Project	IEEE 802.16 Broadband Wireless Access Working Group < http://ieee802.org/16 >	
Title	Advanced ARQ for Relays (15.6.2.8)	
Date Submitted	2009-11-06	
Source(s)	Gauri Joshi, B. Srinadh, Abhay Karandikar, Prateek Kapadia TICET, IIT Bombay	Voice: +91-22-25764473 E-mail: karandi@ee.iitb.ac.in
Re:	IEEE 802.16m-09/0057: Letter Ballot Recirc #30a Target Topic: IEEE P802.16m/D2: Section 15.6.2.8	
Abstract	Modifications to the ARQ protocol to enable efficient scheduling and ensure seamless handover with relays.	
Purpose	Propose inclusion of additional text for Relay ARQ operation in Section 15.6.2.8	
Notice	<i>This document does not represent the agreed views of the IEEE 802.16 Working Group or any of its subgroups.</i> It represents only the views of the participants listed in the "Source(s)" field above. It is offered as a basis for discussion. It is not binding on the contributor(s), who reserve(s) the right to add, amend or withdraw material contained herein.

Advanced ARQ for Relays

Fig. 2- Proposed A-ARQ protocol

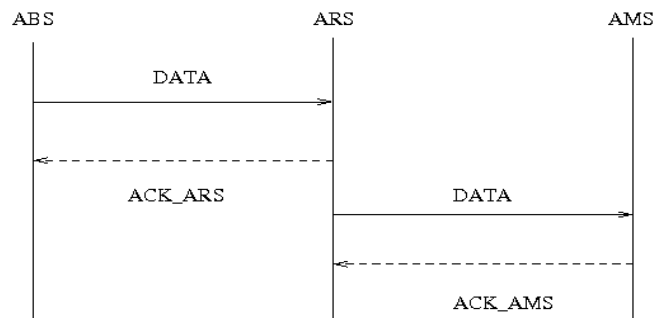
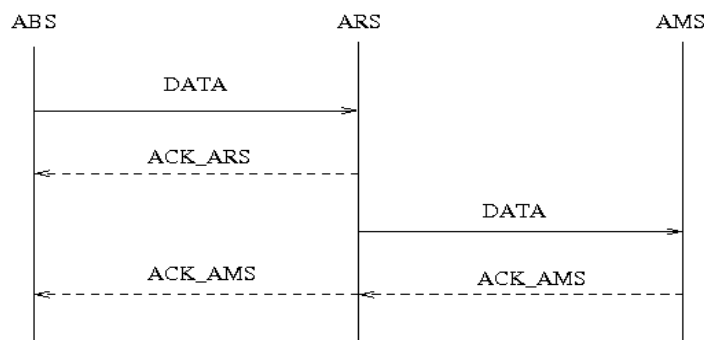
Section 15.6.2.8 of P802.16m/D2 states that ARS performs ARQ operation separately with ABS on the relay link, and AMS on access link. In this protocol, the ABS is unaware of the ARQ state on the access link. Due to this, the current protocol has the following drawbacks:

In the proposed protocol shown in Fig. 2, the ACK or NACK information sent by the AMS to the ARS is also forwarded to the ABS. ABS will clear the ARQ blocks from its buffer only on receiving ACK from AMS, via relay.

ABS maintains two pointers for the ARQ states on relay link and access link. Thus ABS tracks the

state information of ARQ of both these links. In scenarios such as handover from ARS to another ARS, the ABS can set the relay link pointer equal to the access link pointer. It will then start transmission of ARQ blocks to the target ARS from the new relay pointer position. Thus packet loss during handover is averted.

Fig. 3- Access link ARQ feedback sent by ARS to ABS

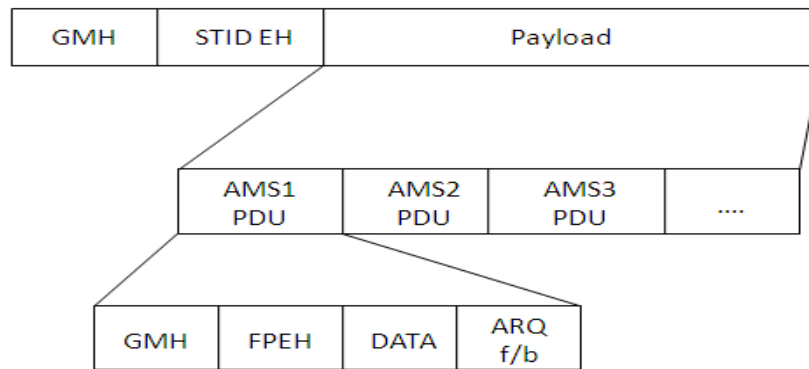
The existing ARQ feedback IE message format can be used to send this additional feedback of access link as shown in Fig. 3. ARS aggregates PDUs from its subordinate AMSs into a single ARQ block. For each AMS, the ARQ feedback can also be piggybacked on its uplink data.

Figure xxx. ARQ transmitter state machine at ABS

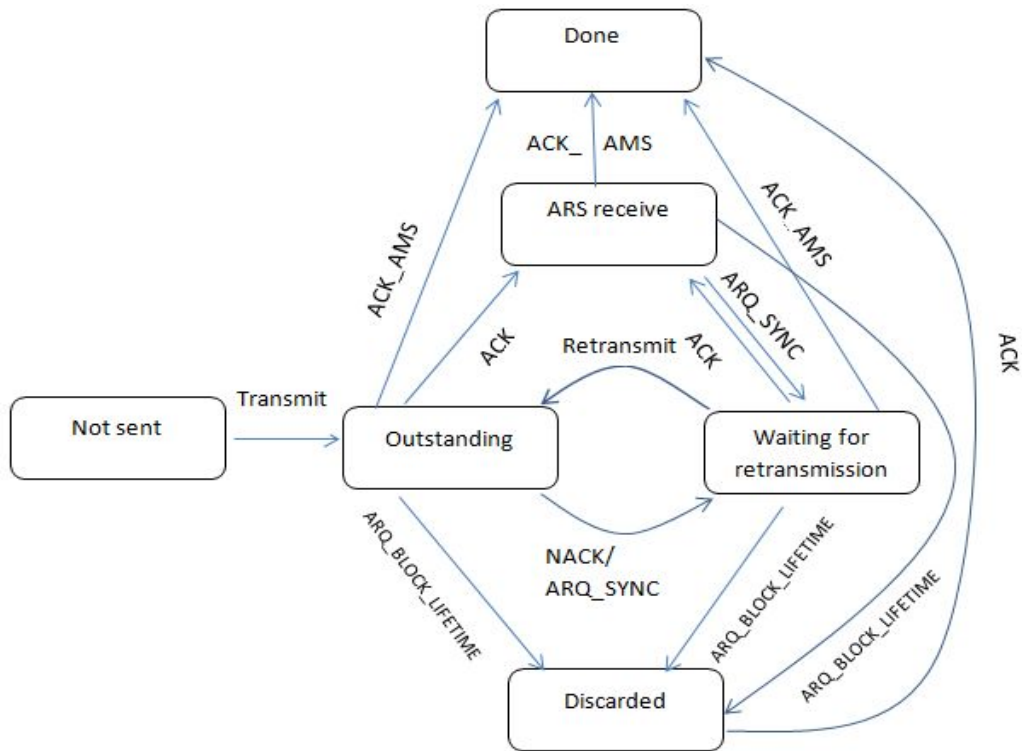
ABS follows a modified version of ARQ transmitter state machine in section 15.2.13.8.2.1.
 ACK: Relay ACK

An ARQ block may be in one of the following six states: not-sent, outstanding, waiting-for-retransmission, discard, ARS receive and done state.

“ARS receive” state: At ABS, ARQ block state transits to this state on reception of ACK. If the transmitter receives ACK_AMS in this state, it transits to “done” state.

“Done” state: ARQ block state transits to this state on reception of ACK_AMS. The ABS shall flush the ARQ block and remove the timers and state variables associated with the flushed ARQ block .

ARQ_SYNC: The ARQ_SYNC trigger condition is generated by the ABS when a handover of the AMS from the serving ARS to another ARS/ABS within the cell occurs. It is also generated if the ARS requests ABS for synchronization of ARQ states for a flow.

When ARQ_SYNC trigger occurs, the ABS synchronizes its ARQ states with the AMS as follows:

- ARQ blocks in “outstanding” and “ARS receive” states transit to “waiting for retransmission” state.
- ARQ_TX_WINDOW_START and ARQ_TX_NEXT_SN are made equal to ARQ_TX_WINDOW_BEGIN.
